ADMINISTRATIVE AMENDMENT

Proposed site revision for the America First Credit Union tenant improvement: Remove portion of existing storefront windows and add a walk-up ATM to the existing exterior wall.

PROJECT TITLE: SHOPPES OF ALAMEDA
 NM STATE HIGHWAY 528 (ALAMEDA) & COORS BLVD.
 ALBUQUERQUE, NEW MEXICO

AFCU - ALBUQUERQUE BRANCH
 3400 HIGHWAY 528
 ALBUQUERQUE, NM

1 NORTH ELEVATION
SCALE: 1/8" = 1'-0"

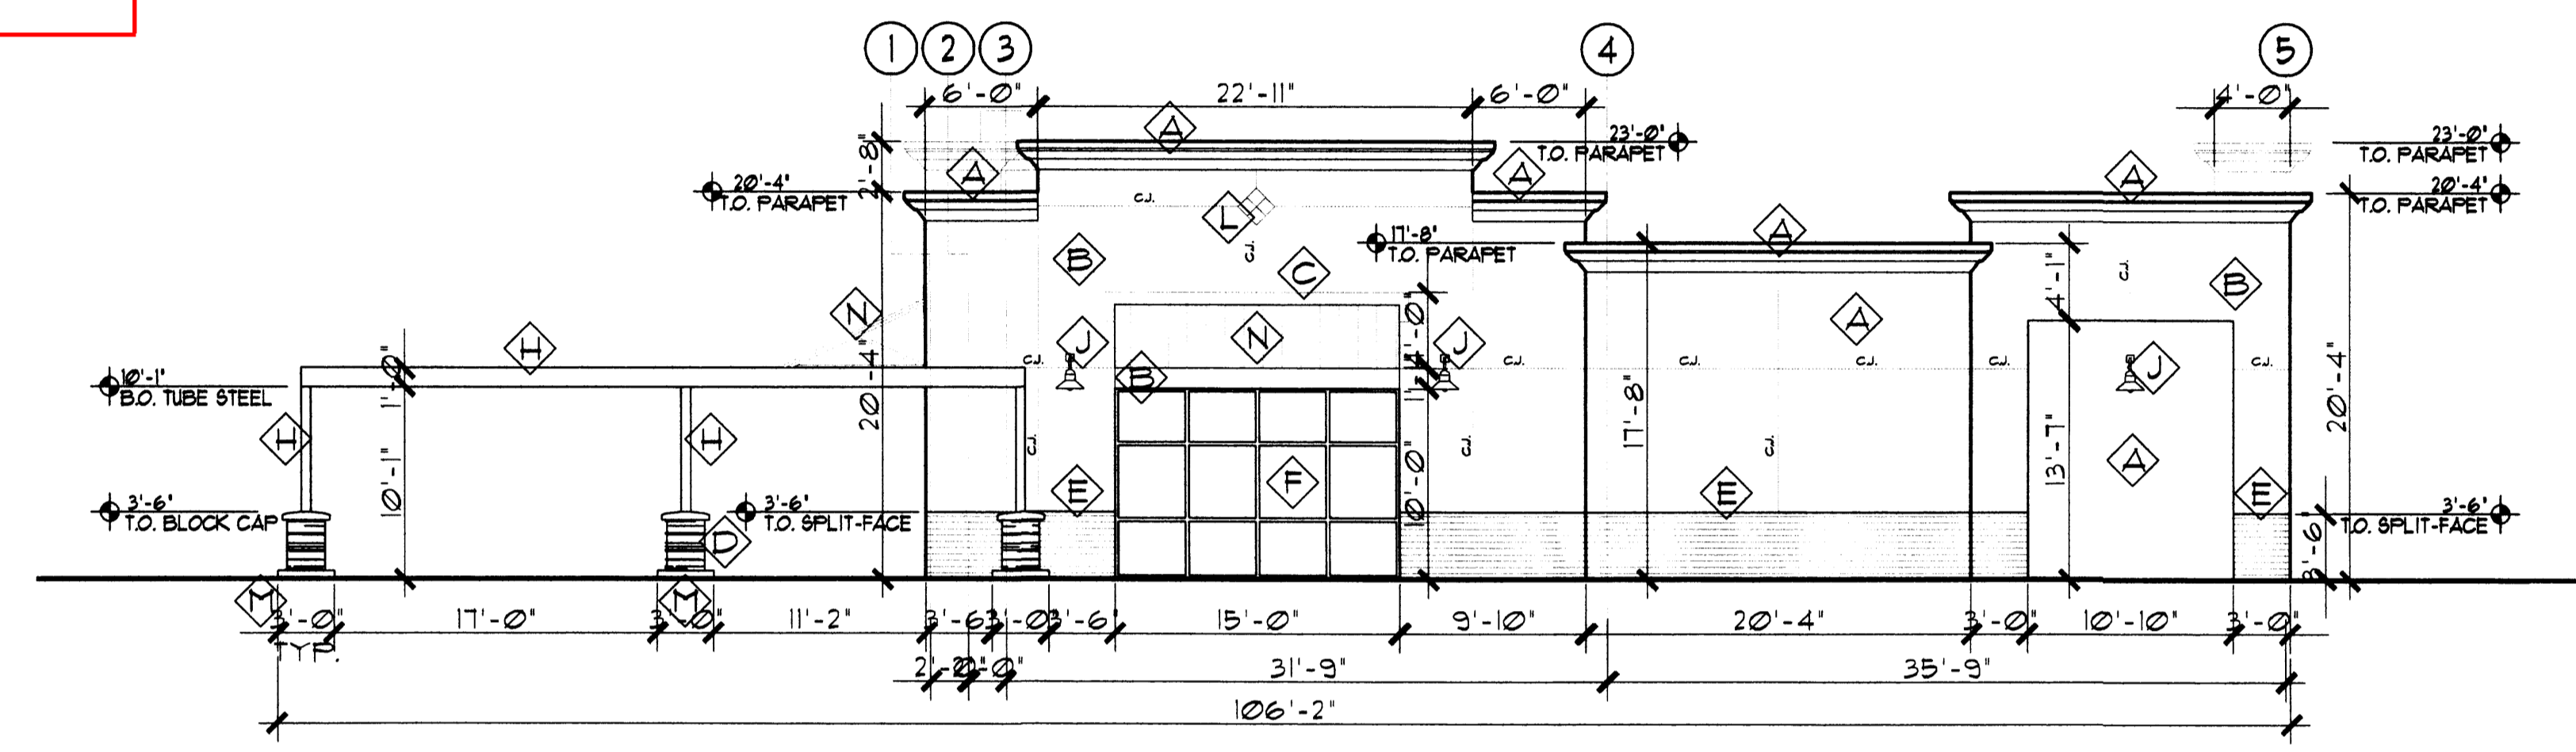
Proposed site revision for the America First Credit Union tenant improvement. Remove portion of existing storefront windows and add a walk-up ATM to the existing exterior wall.

DEMOLITION ELEVATIONS

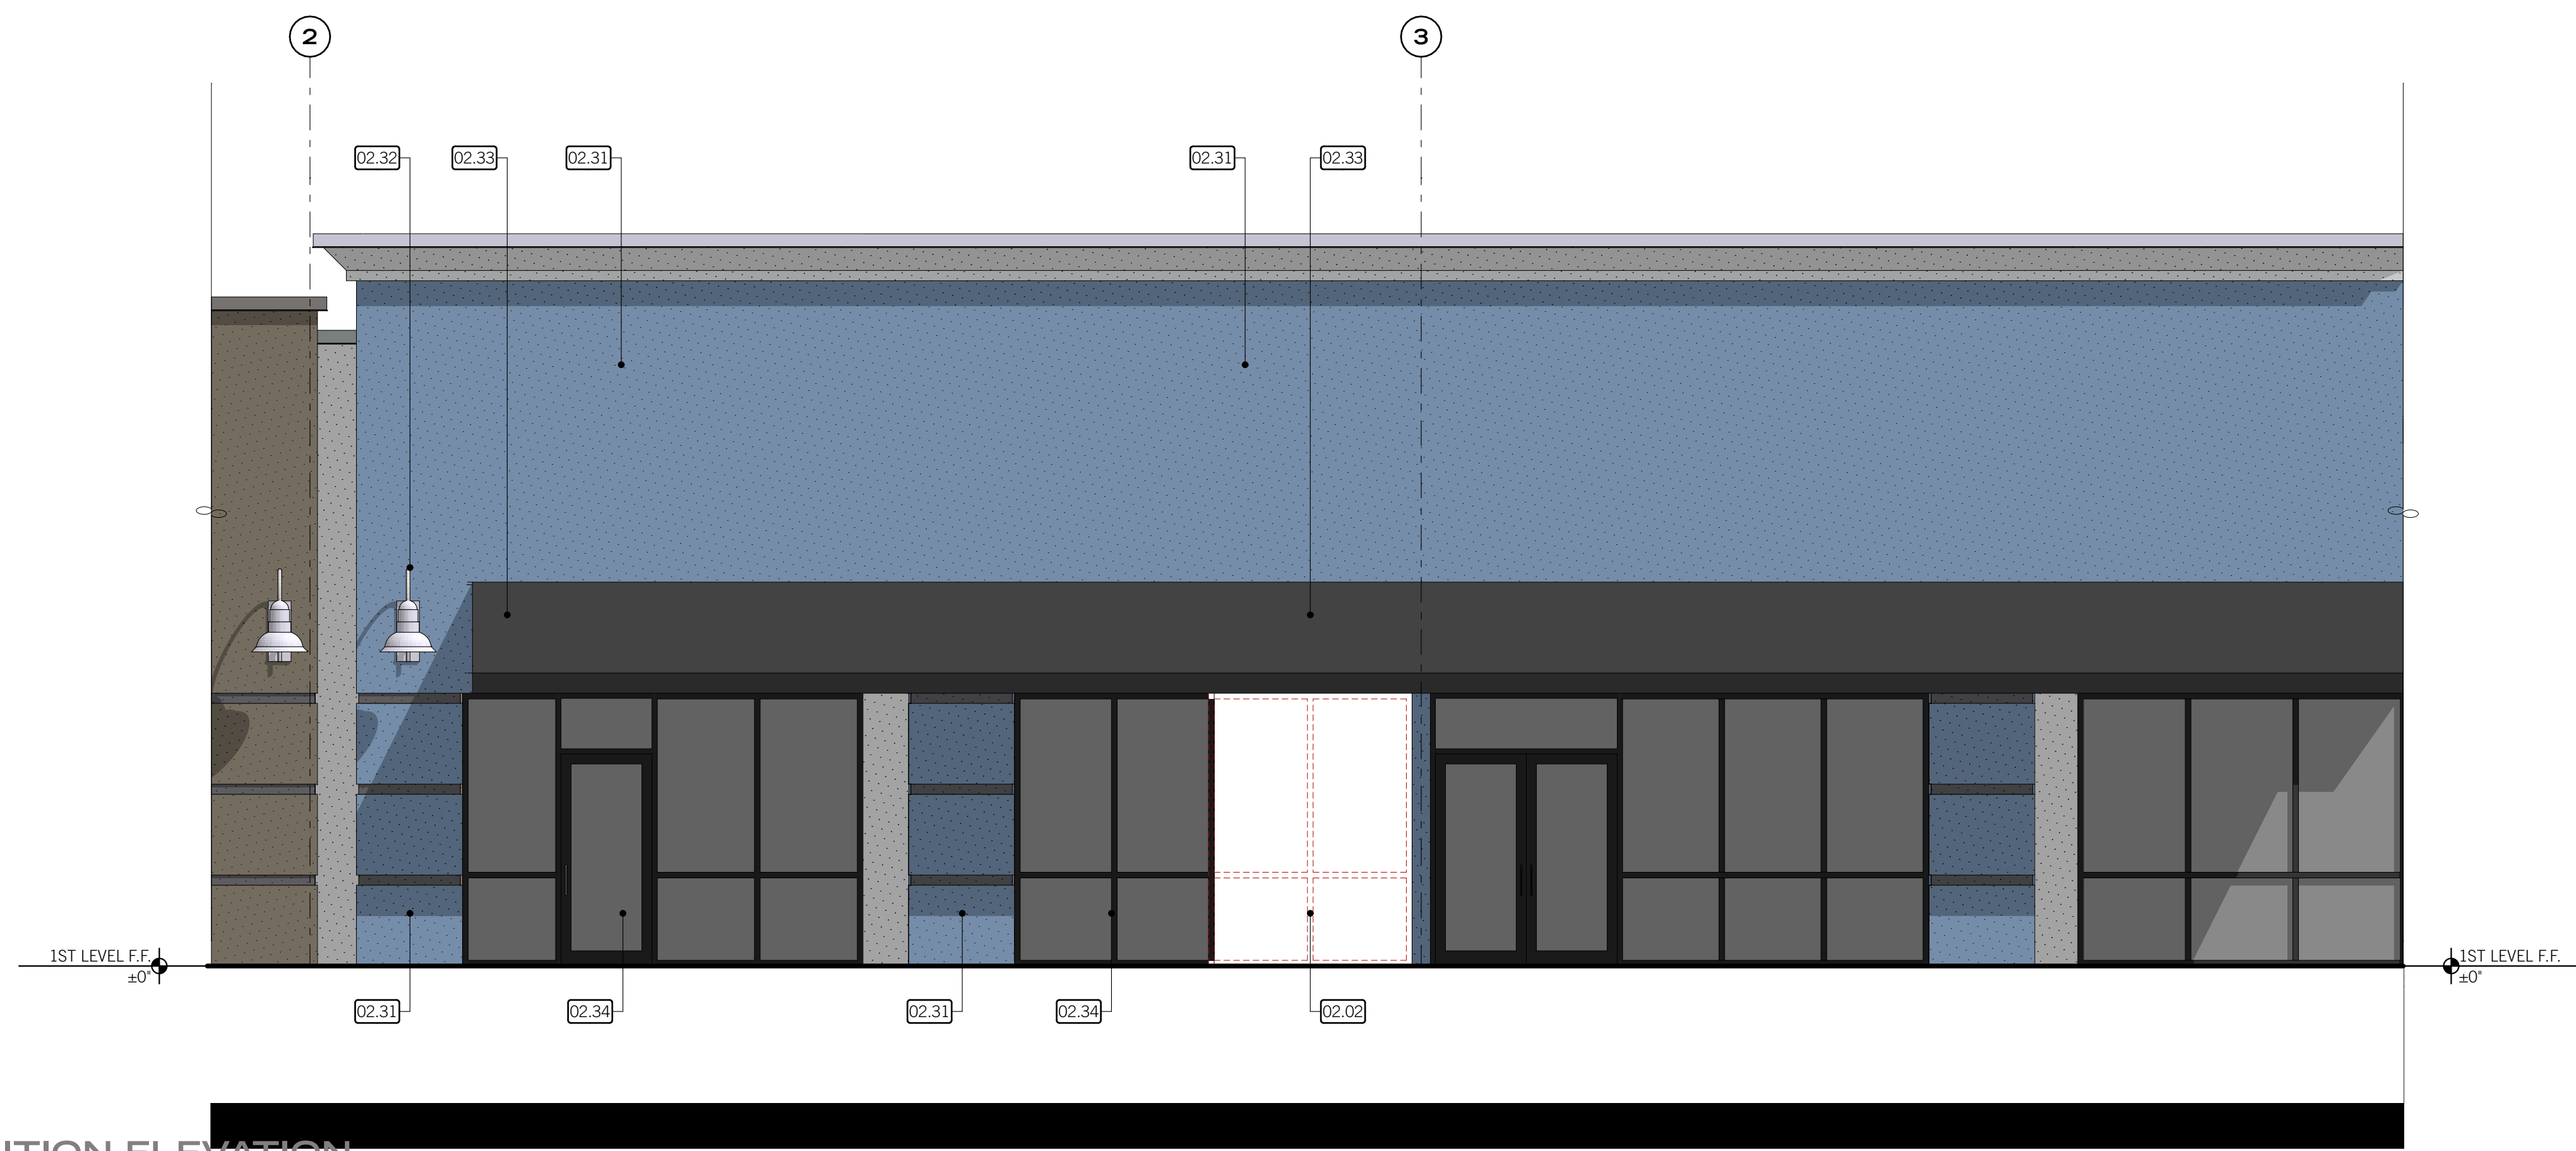
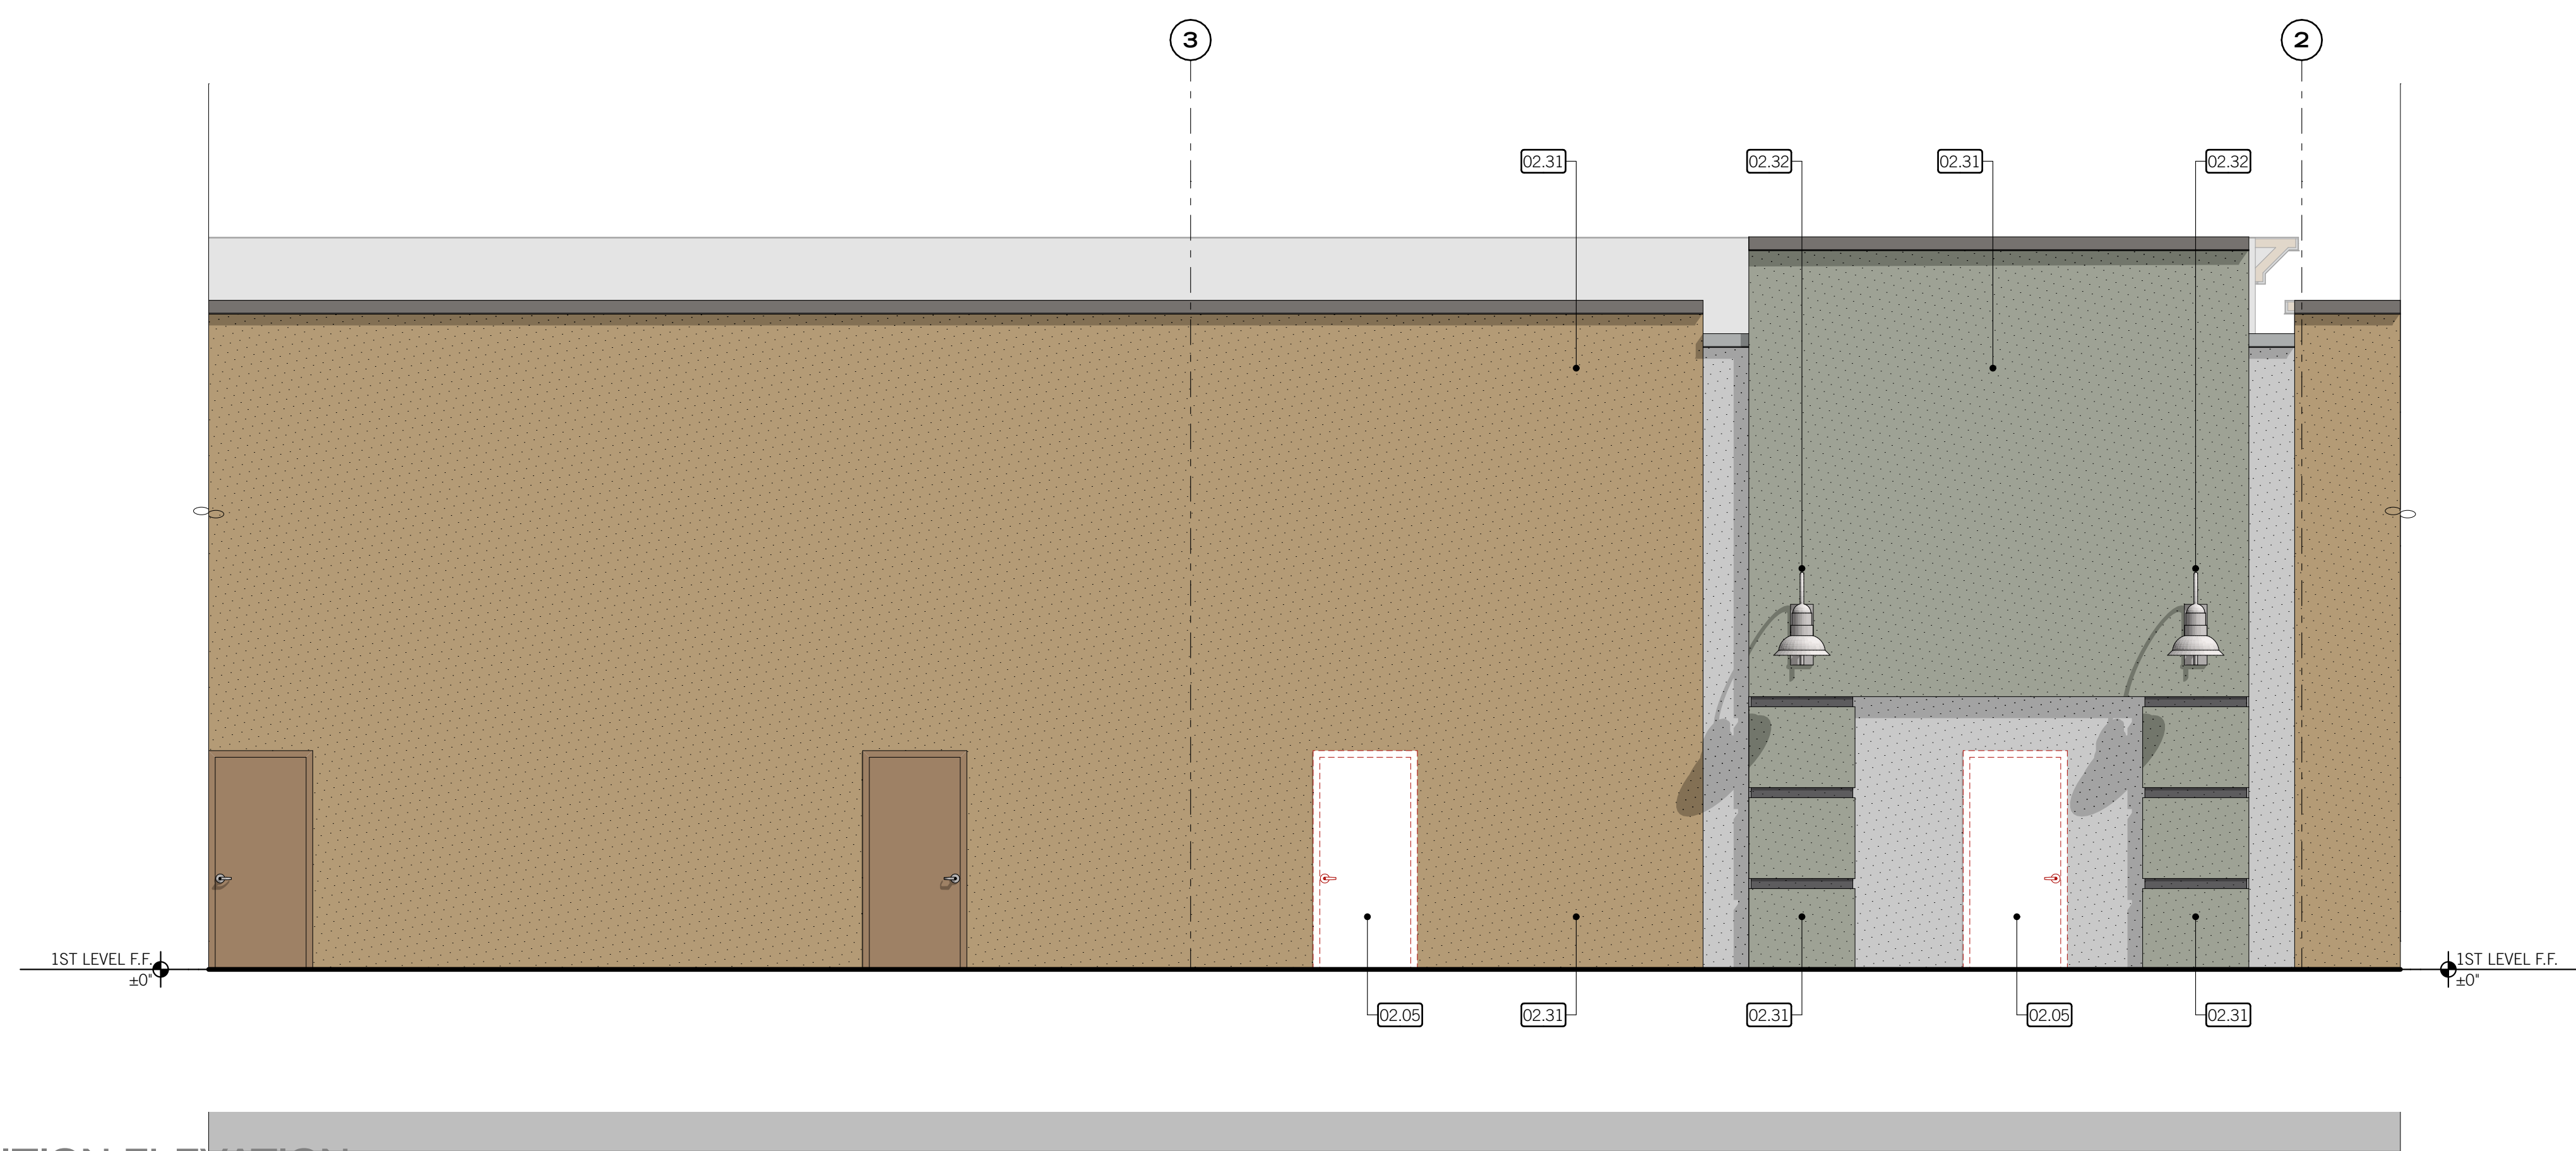
- 02.02 Remove portion of existing aluminum storefront system as shown.
- 02.05 Remove existing metal door and hollow metal frame, complete.
- 02.31 Existing EIFS system - protect from damage
- 02.32 Existing light fixture to remain - protect from damage
- 02.33 Existing awning system to remain - protect from damage
- 02.34 Existing aluminum storefront system to remain - protect from damage

EXTERIOR ELEVATIONS

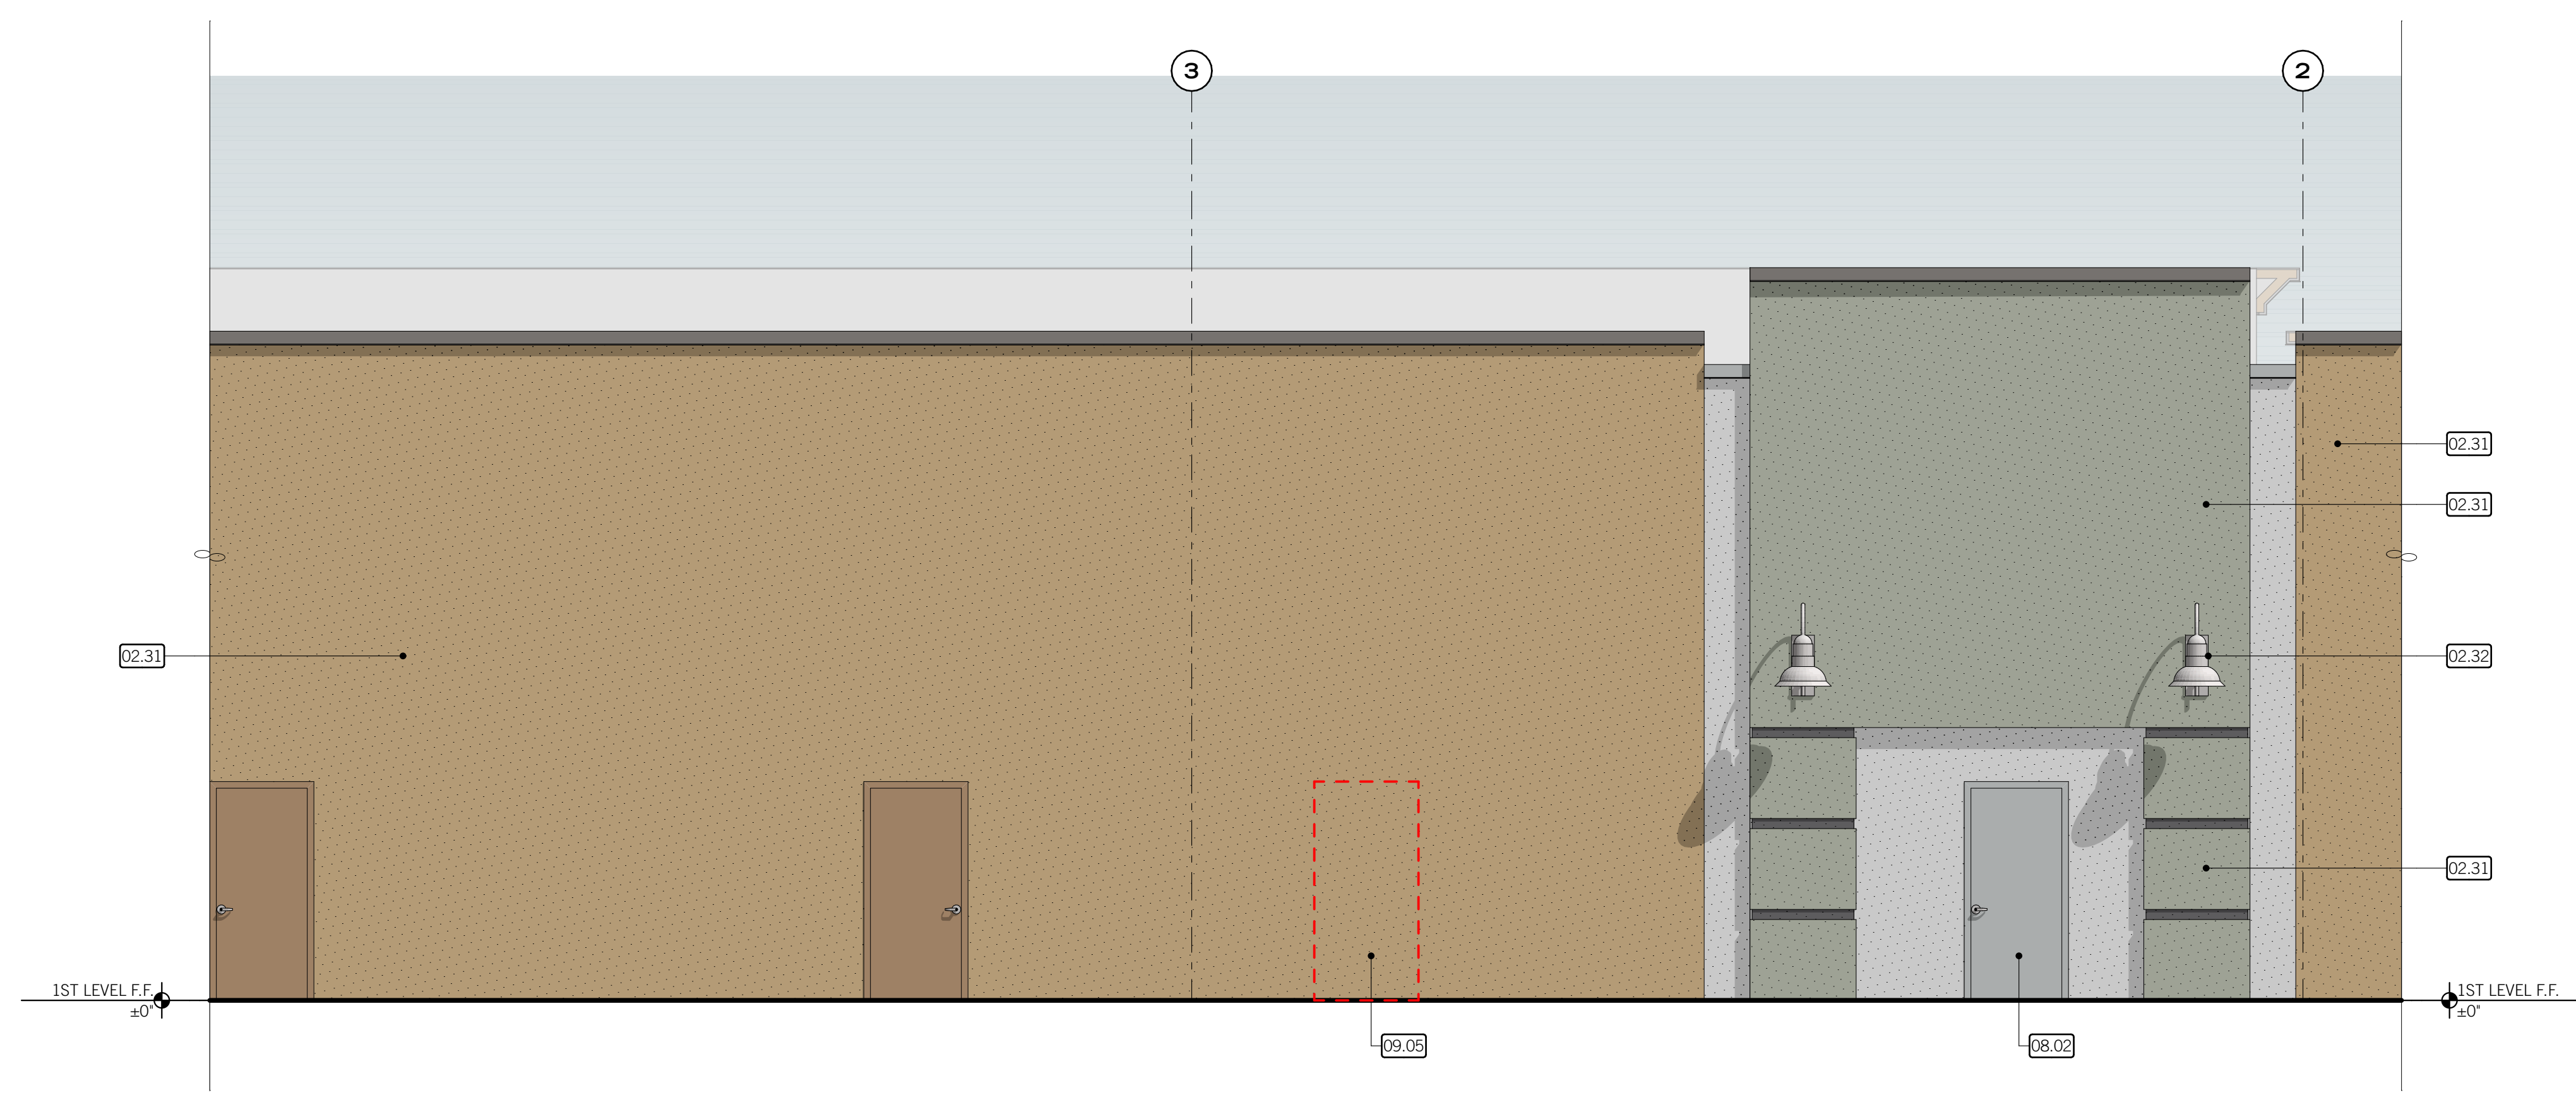
- 02.34 Existing aluminum storefront system to remain - protect from damage
- 07.02 New EIFS system to match existing - paint to match adjacent existing EIFS system.

- 08.02 Install new hollow metal door and frame in existing wall opening - paint. Re: door schedule. Patch and repair existing EIFS system as required.

- 09.05 Infill existing wood framed exterior partition with wood framing and batt insulation to match existing at location of demolished storefront/hollow metal door system. Install 5/8" gypsum board at inside face of wall to match existing. Skim coat wall to provide smooth level finish - paint. Install plywood wall sheathing and exterior EIFS system to match existing @ exterior. Paint existing EIFS adjacent to existing storefront opening to match new EIFS.

- 09.18 Infill existing wood framed exterior partition with wood framing and batt insulation to match existing at location of demolished storefront system. Install 5/8" gypsum board at inside face of wall to match existing. Skim coat wall to provide smooth level finish - paint. Install plywood wall sheathing and exterior EIFS system to match existing @ exterior - re: exterior elevations. Coordinate opening dimensions with ATM supplier. Install stainless steel flashing around ATM wall opening where occurs. Paint existing EIFS adjacent to existing storefront opening to match new EIFS. Re: detail 06A1.2.

- 10.05 Building mounted exterior sign by Owner. Provide electrical power as per electrical drawings.
- 11.08 ATM machine (N.I.C.) - provided by Owner's Equipment Contractor - re: equipment plan. Coordinate rough opening dimensions in exterior wall with Owner's Equipment Contractor. Re: detail 06A1.2 for stainless steel flashing at opening.
